SONY

Hi-Fi Products
Service Bulletin

Model: HCD-H7/H1500

No. 290

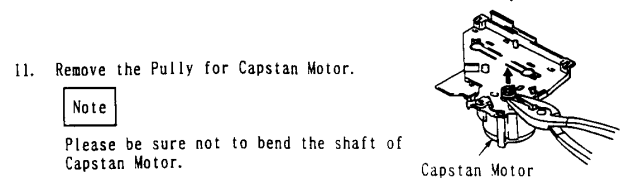
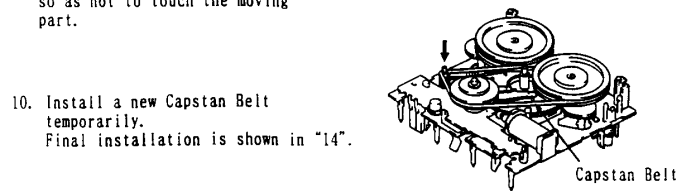
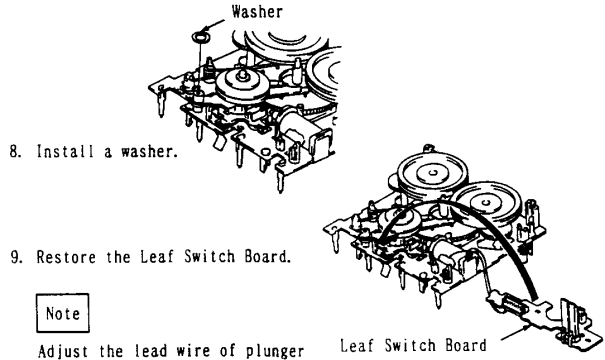
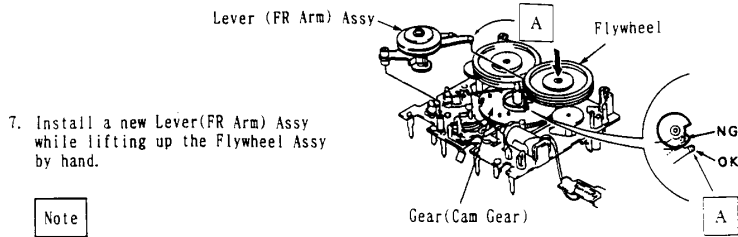
3. Lift up the Flywheel by hand and remove the Lever(FR Arm) Assy.

4. Lift up the Slider(Brake Plate) in the direction shown by arrow.

5. Stick the Spacer(FR Arm) to  part on the chassis after cleaning  area with alcohol.

6. Restore the Slider(Brake Plate) in the direction shown by arrow.

Make sure if twisted coil spring installed with Slider(Brake Plate) can be out of position.

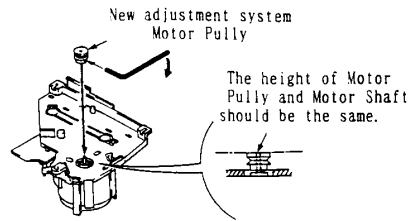
12. Install a new motor to the same height of motor shaft temporarily.

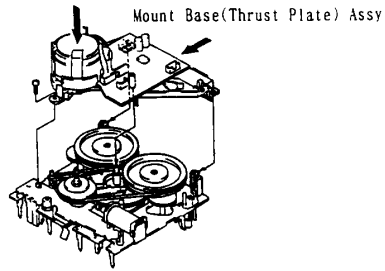
13. Restore the Mount Base(Thrust Plate) Assy.

14. Put the Capstan Belt to the Capstan Motor Pulley.

Make sure not to twist Capstan Belt.

15. Align the height of Flywheel, Lever(FR Arm) Assy and Motor Pulley in order to make them in parallel.

16. After pressing washer on Capstan Shaft until it reaches to the shaft receiver, clean the Capstan Shaft with alcohol.
